Model	3.5KLCT for F400/410	Volt/Hz	Date of Modification	Serial Number
Modified Article	Parts Catalog			
Reason for Modification	Parts catalog correction

Model	3.5K LCT for F400/F410	Volt/Hz	Date of Modification	Serial Number
Modified Article	LCT Tray			
Reason for Modification	Due to vender change

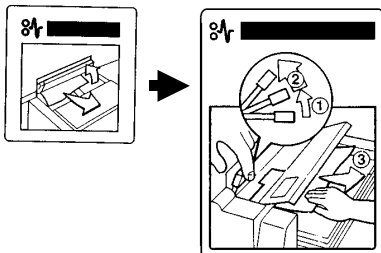
Please correct your parts catalog as follows:

Incorrect P/N	Correct P/N	Description	Q'ty Used	Parts Catalog	
				Index No.	Page
A3801393	A3801293	Actuator	1	40	9

1. Decal - Misfeed Removal

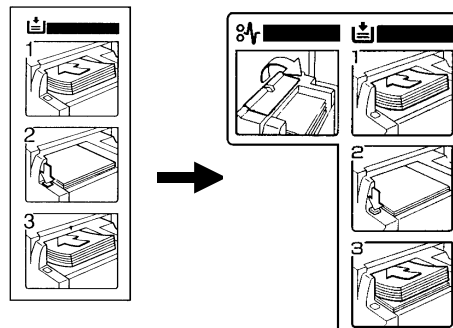
Model	3.5K LCT for F400 / 410 / 420	Volt/Hz	Date of Modification	Serial Number
Modified Article	Decals			
Reason for Modification	To improve operation

To improve operation (jam removal at 3.5K LCT) the decals have been modified.

Old P/N	New P/N	Description	Q'ty Used	Inter-changeability	Parts Catalog	
					Index No.	Page
A3801132	A3801182	Decal - Misfeed Removal (RICOH)	1 → 1	X/O	17	5
A3801134	A3801184	Decal - Misfeed Removal (Gestetner)			43	9
A3801136	A3801186	Decal - Misfeed Removal (Infotec)			2	15
A3801138	A3801188	Decal - Misfeed Removal (SAVIN)				
A3801131	A3801181	Decal - Paper Setting (RICOH)	1 → 1	X/O	16	5
A3801133	A3801183	Decal - Paper Setting (Gestetner)				
A3801135	A3801185	Decal - Paper Setting (Infotec)			1	15
A3801137	A3801187	Decal - Paper Setting (SAVIN)

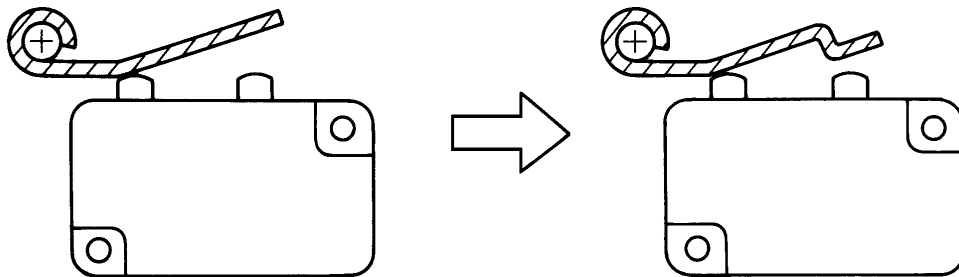
Model	3.5K LCT for F400 / 410 / 420	Volt/Hz	Date of Modification	Serial Number
Modified Article	Micro Switch Plate / Pressure Spring			
Reason for Modification	To improve the microswitch detection

Old P/N	New P/N	Description	Q'ty Used	Inter-change-ability	Parts Catalog	
					Index No.	Page
A3801297	A3801299	Pressure Spring	1 → 1	X/O	39	9
A3801358	A3801359	Micro Switch Plate	1 → 1	X/O	11	9

To improve the microswitch detection, the shape of the microswitch plate has been changed. Also, the pressure of the spring has been increased from 2000gf mm to 2400gf mm. For details, please refer to RTB No. 026.

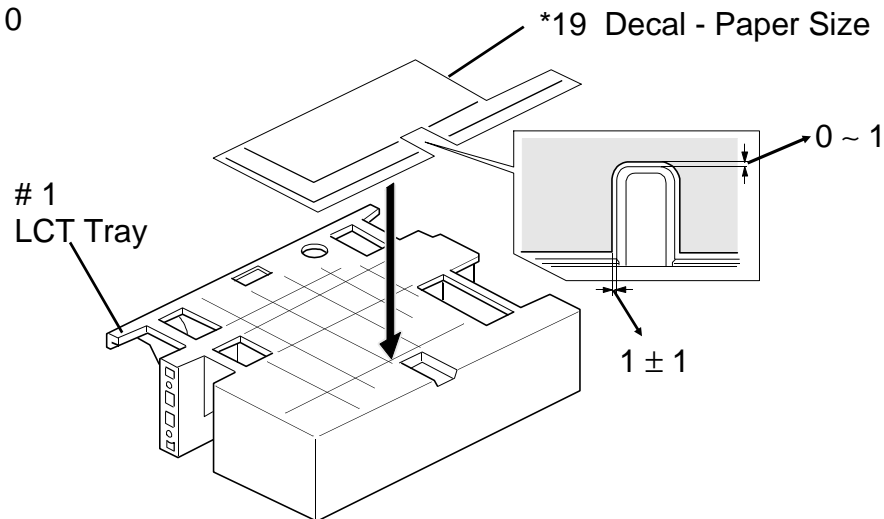
Model	3.5K LCT for F400 / 410 / 420	Volt/Hz	Date of Modification	Serial Number
Modified Article	Decals - Paper Size			
Reason for Modification	As per factory request

New P/N	Description	Q'ty Used	Parts Catalog	
			Index No.	Page
A3801141	Decal - Paper Size	0 → 1	* 19	11

As per a factory request, a paper size decal has been stuck on the LCT tray instead of by printing. When replacing the LCT tray, please stick the decal on it. The part number of the LCT tray is not changed.

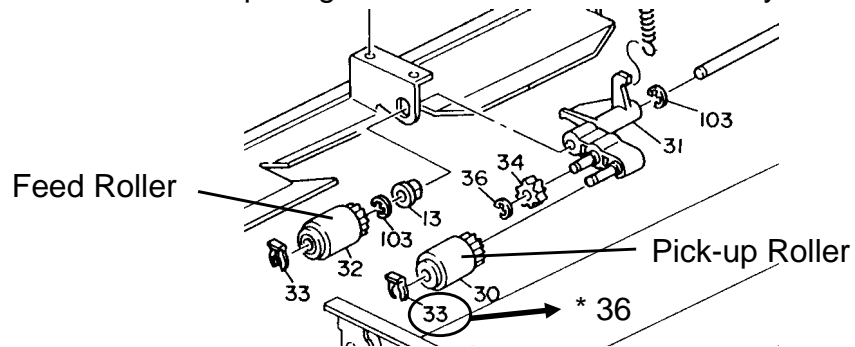
1. Index numbers for the paper feed and pick-up rollers are reversed. Please correct them as follows:

P/N	Description	Parts Catalog		
		Index No.		Page
		Incorrect	Correct	
AF031021	Paper Feed Roller	30	32	7
AF030021	Pick-up Roller	32	30	7

Old P/N	New P/N	Description	Q'ty Used	Parts Catalog	
				Index No.	Page
54472681		Snap Ring	2 → 1	33	7
	52152621	Snap Ring - M6	0 → 1	* 36	7

NOTE: The Snap Ring Part No. for the feed roller stays the same.

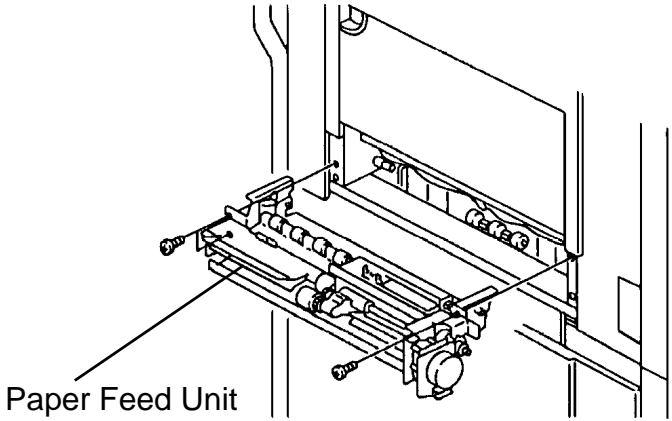
Model	LCT for F400 / 410 / 420	Volt/Hz	Date of Modification	Serial Number
Modified Article	Paper Feed Unit			
Reason for Modification	Per field request

New P/N	Description	Q'ty Used	Parts Catalog	
			Index No.	Page
A3800200	Paper Feed Unit	0 → 1	*	7
